STAFF RECOMMENDATION 1703 Primrose Avenue July 19, 2017

Application: New construction-setback determination
District: Belmont-Hillsboro Neighborhood Conservation Zoning Overlay
Council District: 18
Map and Parcel Number: 1170805300
Applicant: Van Pond Architects
Project Lead: paul.hoffman@nashville.gov

<p>Description of Project: A new detached accessory dwelling unit (DADU) was approved in March with a setback determination of five feet (5') from the rear property line. The applicant requests a setback determination to locate the new outbuilding on the rear property line.</p> <p>Recommendation Summary: Staff recommends disapproval of the setback determination. Staff finds that the proposed setback determination would not meet section II.B.1 of the design guidelines.</p>	<p>Attachments A: Site Plan</p>
--	---

Figure 1. Buffer area behind the house

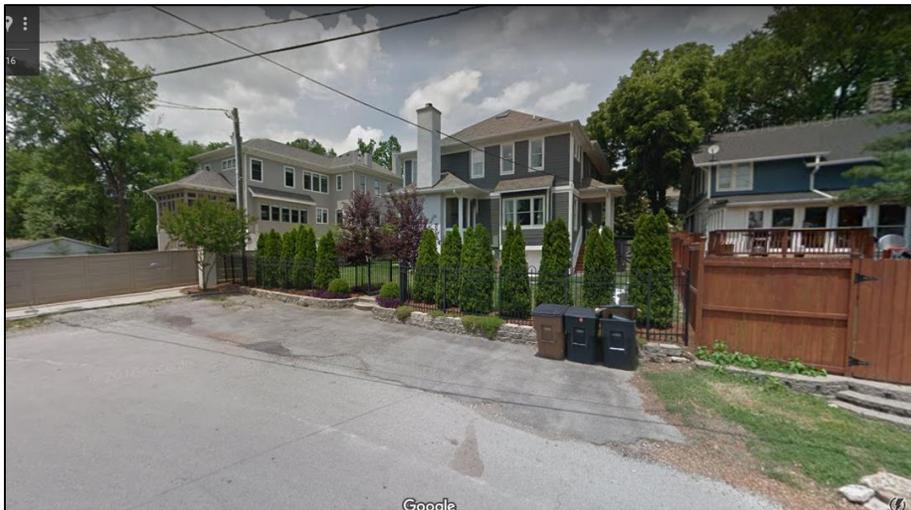
Setback: Previously the Commission approved a reduced setback from ten feet (10') to five feet (5'). The lot is unusual, being shorter than other lots in the district, and with the rear property line abutting the street right-of-way for Oakland Avenue. Outbuildings located near the rear property line are common historically. However, Staff finds that the already-approved rear setback is as close as should be recommended. Staff finds locating the outbuilding closer than five feet (5') or on the rear property line would not meet section II.B.i of the design guidelines for location. Typically outbuildings were close to the rear property line but they were not necessarily on the property line. Since the proposed outbuilding is much larger than historic buildings, staff recommends that the building be no closer than five feet (5') from the rear property line. The Commission has approved outbuildings with garage doors facing the rear as close as five feet (5') to the rear property line, but no closer. Metro Public Works reviewed this specific request and does not support a structure immediately adjacent to the right-of-way.

Recommendation Summary: Staff recommends disapproval of the requested setback determination, finding that further reduction would not meet section II.B.1 of the design guidelines for the Hillsboro-West End Neighborhood Conservation Zoning Overlay.

1 Proposed Site Plan

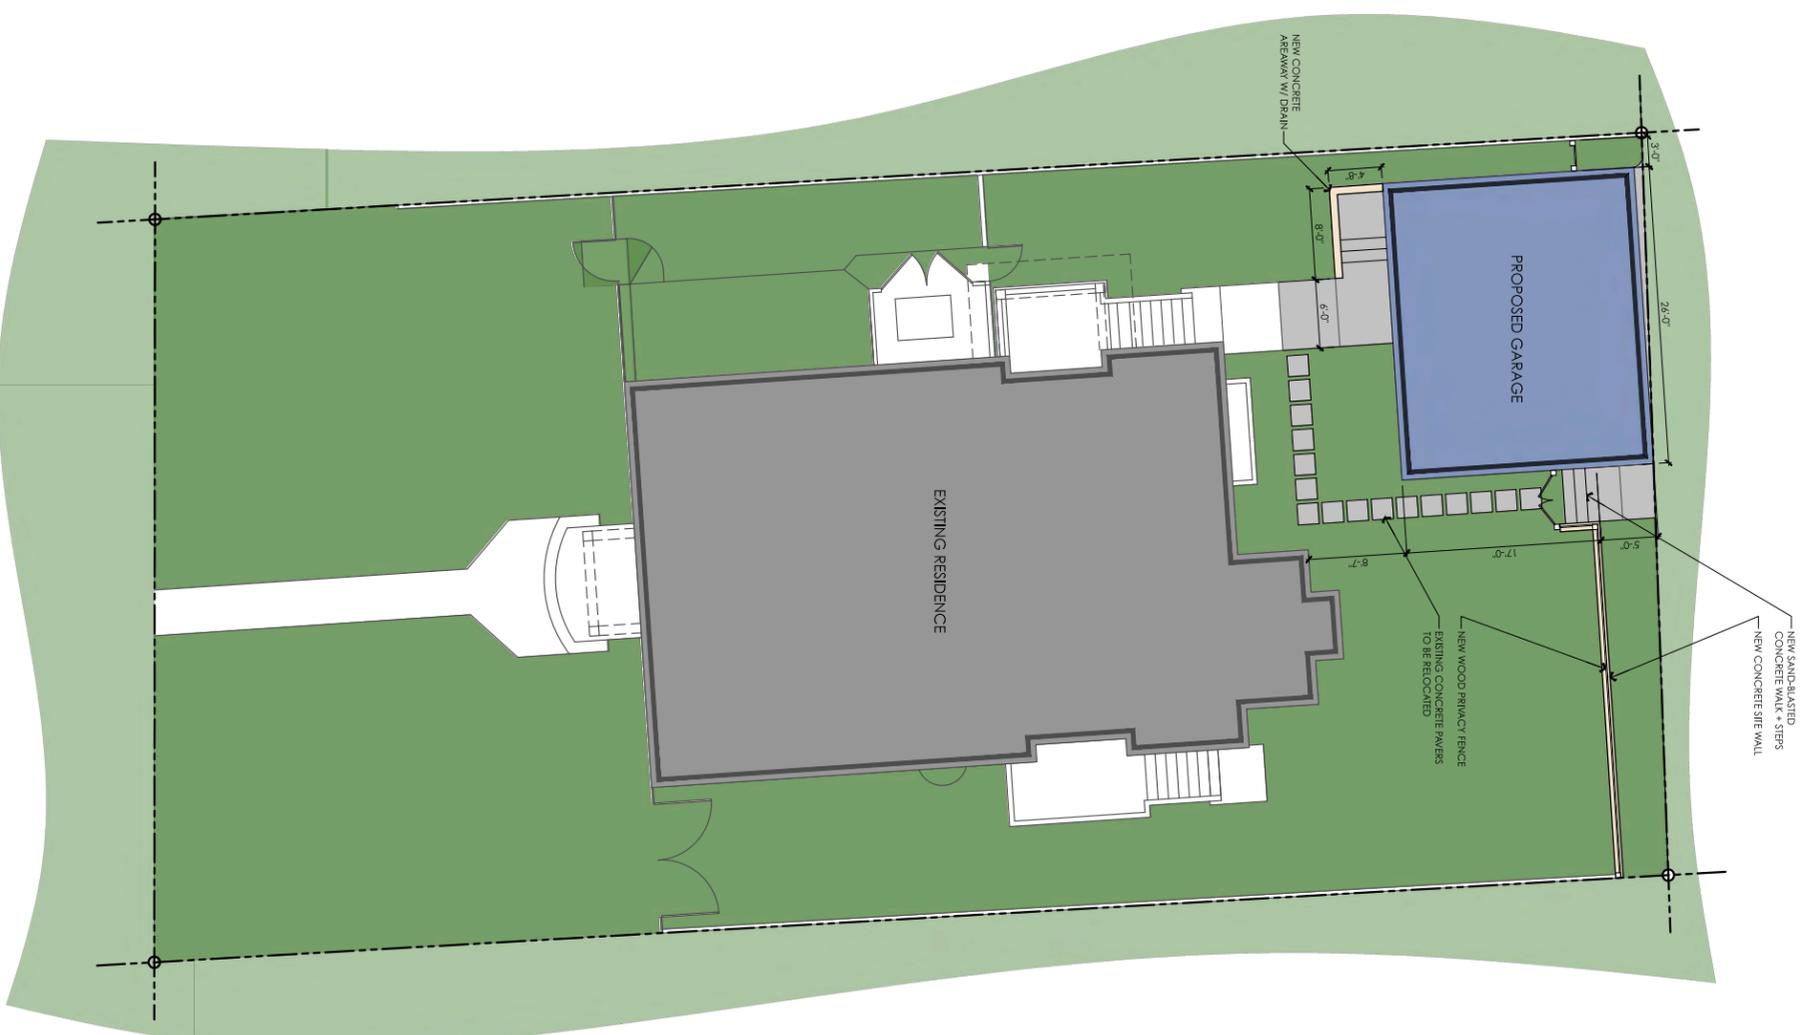
Analysis and Findings: MHZC approved construction of the detached accessory dwelling unit (DADU) in March, with a rear setback determination of five feet (5'). The applicant requests further reduction of the rear setback, proposing to locate the new DADU on the rear property line.
